4516 Union Bay Place NE

DESIGN REVIEW BOARD MEETING - FEBRUARY 22, 2016

(DPD #3019495)

RE: DPD Project #3019495
Project Address: 4516 Union Bay Place NE
Response to MUP Cycle 1 Corrections – ECA SLIDE AND ECA PEAT

SECTION FROM EDG SHOWING
2 1/2 STORIES OF PARKING IN A
CONTINUOUS SPIRAL

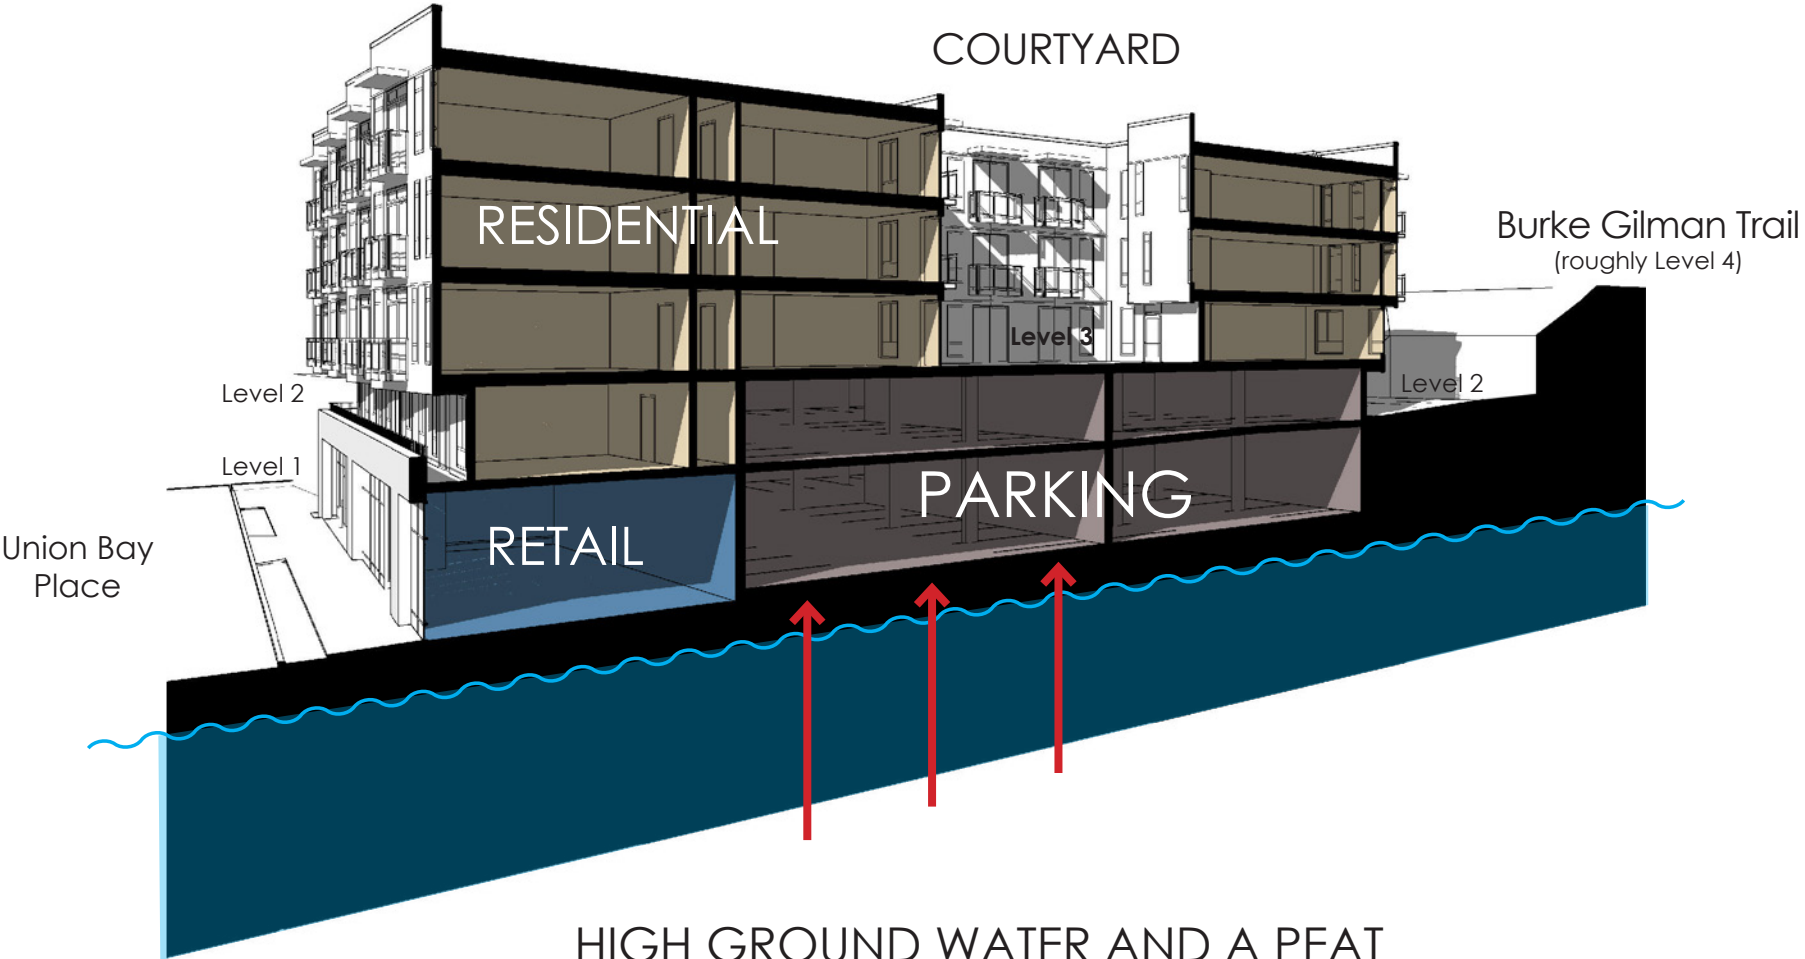
4 Access to Parking (23.47A.032.A.3)

HIGH GROUND WATER AND A PEAT
SETTLEMENT ENVIRONMENTAL CRITICAL
AREA REQUIRE THE PARKING TO BE
PUSHED UP OUT OF THE GROUND

TO RESPOND TO PEAT SETTLEMENT
ECA PARKING IS NOW TWO SEPARATE
LEVELS FOR EFFICIENCY AND REQUIRES
SEPARATE ENTRIES TO FUNCTION

East Elevation - Burke Gilman Trail

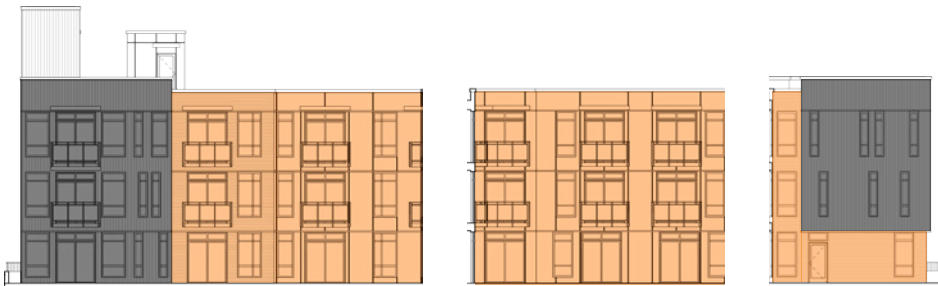
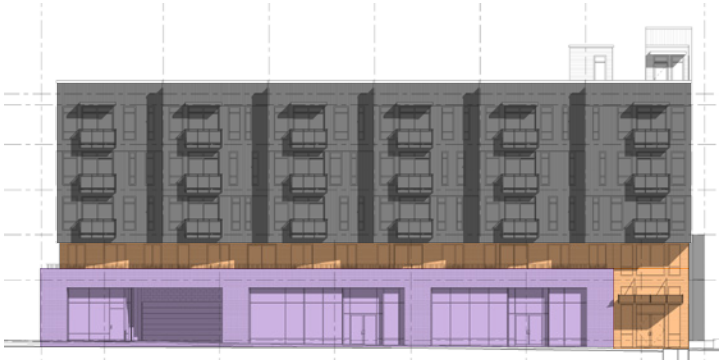
b. Demonstrate how the materials respond to the design Concept, for each façade. (DC2-B)

Metal standing seam shingle siding

Vinyl window frames

Powder coated metal balcony and railings

Wood-tone stained manufactured lap siding

Cast-in-place concrete

Durable brick at the retail bar

4 Access to Parking (23.47A.032.A.3):

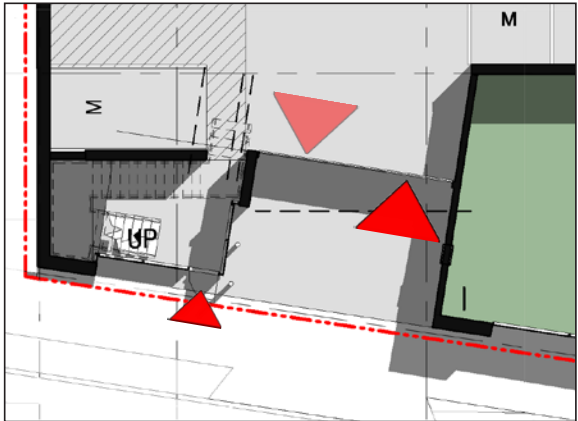
...provide studies and graphics demonstrating how the departure would impact the streetscape and pedestrian experience; how retail users get from the parking to the retail uses, lobby, and adjacent structures; and how the parking entry interfaces with the adjacent property to the north.

A concave mirror on this location expands what a driver exiting the garage can see.

Bumpy pavement treatment in this area gets the attention of both pedestrians and drivers.

Transparent corner also increases visibility for drivers exiting the garage and for pedestrians coming and going.

PRIVACY ALONG NORTH FACADE

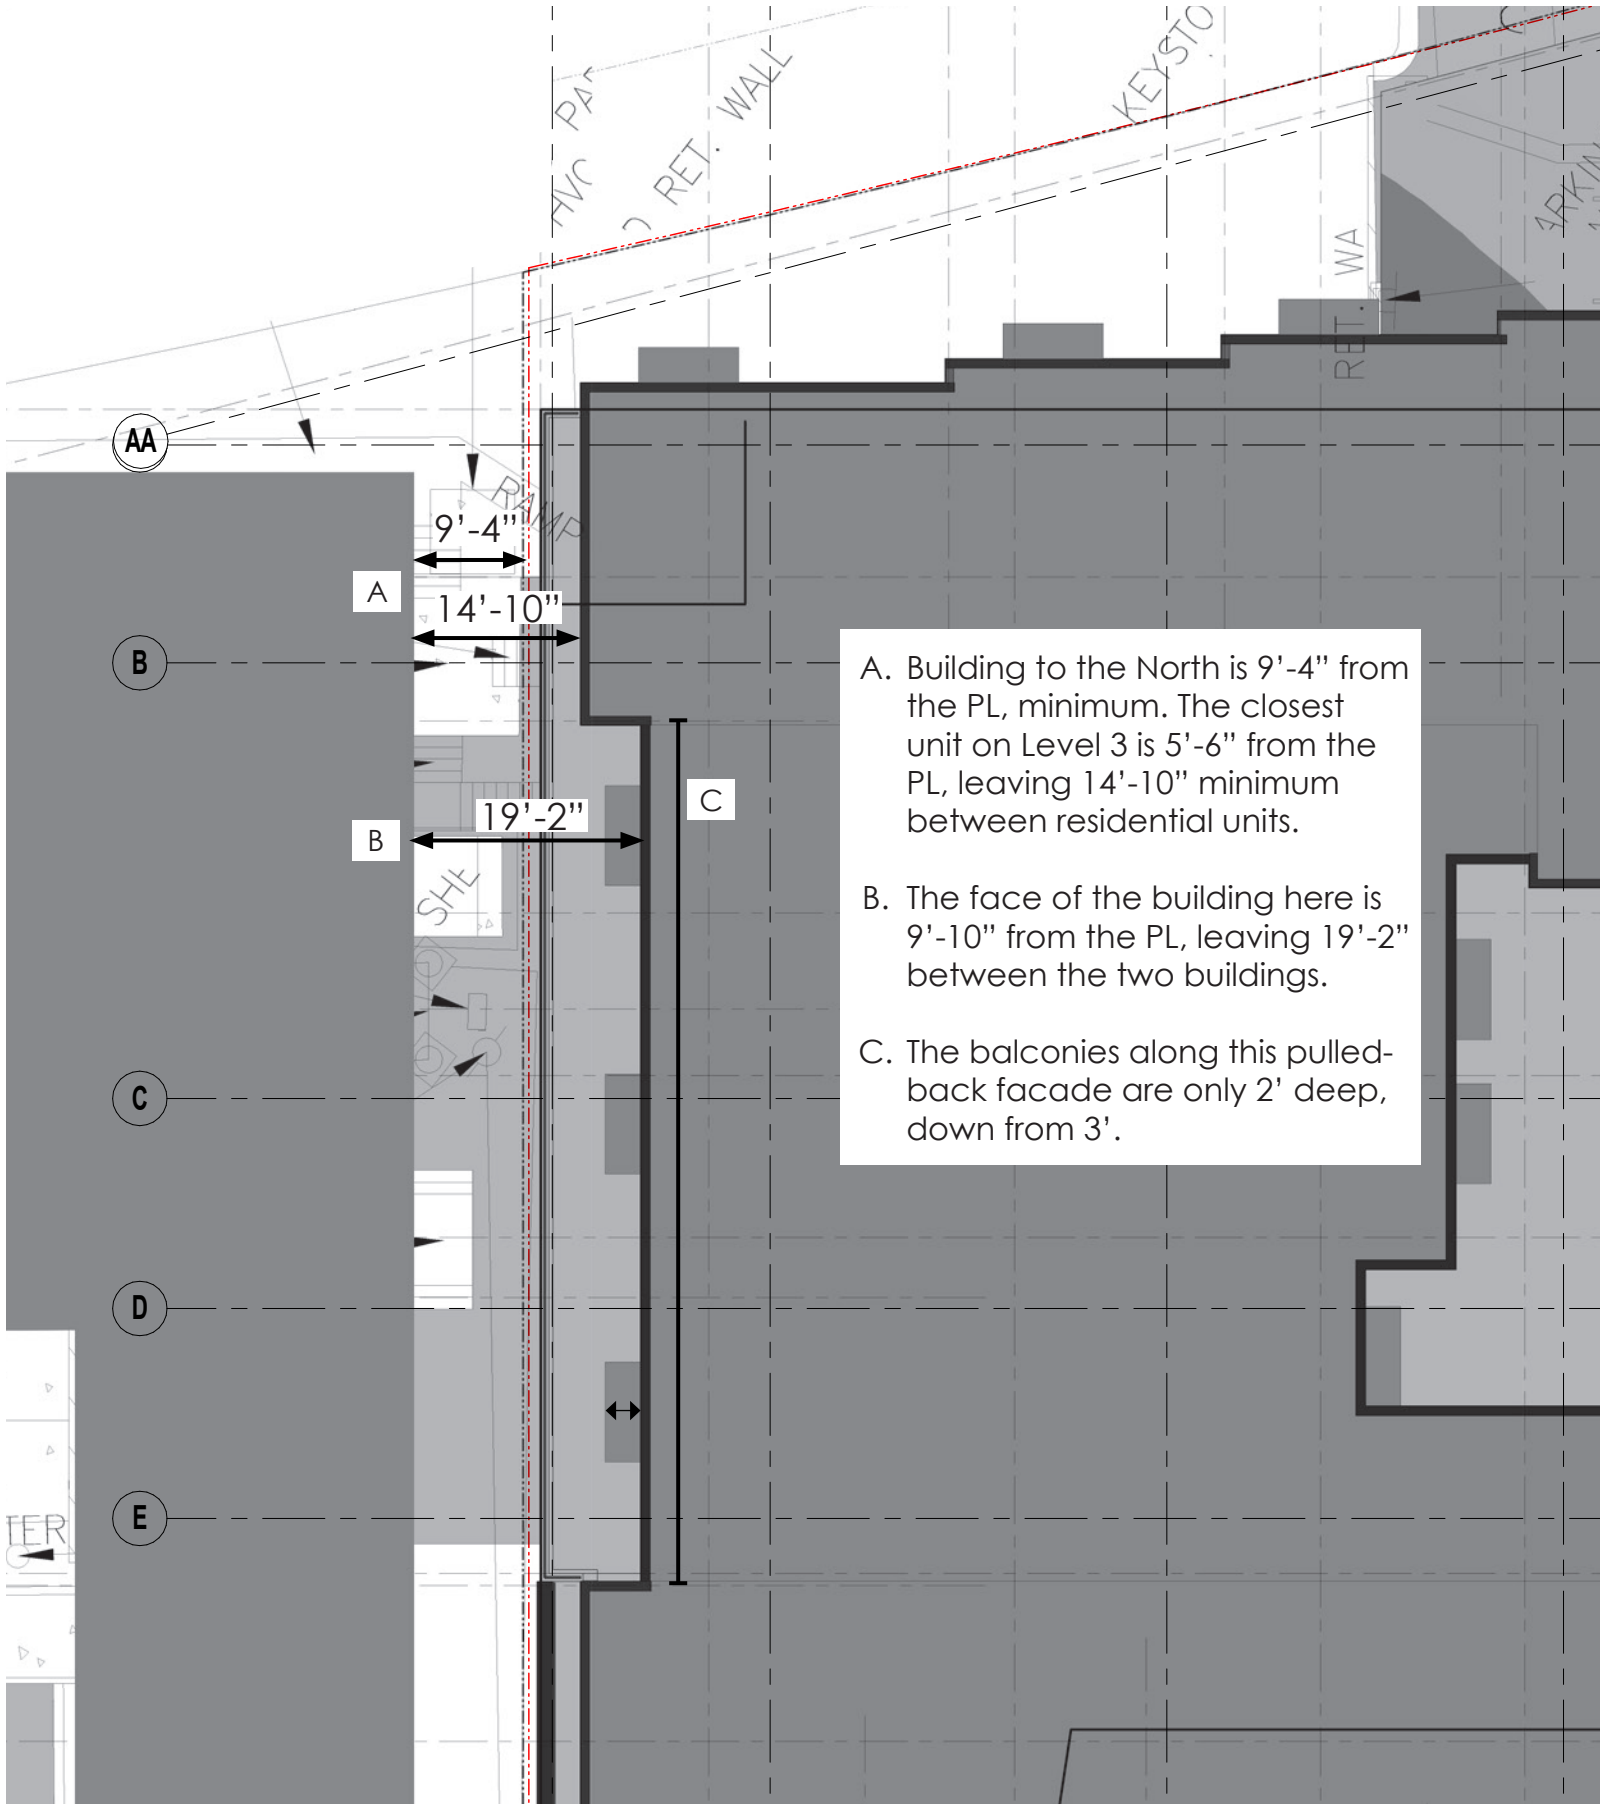
8 North façade, balconies and patio. At EDG, the Board expressed concern over the location of the balconies as related to potential future privacy concerns. Please include dimensions from the building and balconies to the property line, and demonstrate how privacy will be addressed.

Building to the North is 9'-4" from the PL, minimum. The closest unit on Level 3 is 5'-6" from the PL, leaving 14'-10" minimum between the two buildings.

The face of the building here is 9'-10" from the PL, leaving 19'-2" between the two buildings.

The balconies along this pulled-back facade are only 2' deep, down from 3'.

Dimensions have been included. The depth and size of the balconies along the north wall have been reduced so there is now more separation to the property line. See sheet A2.04
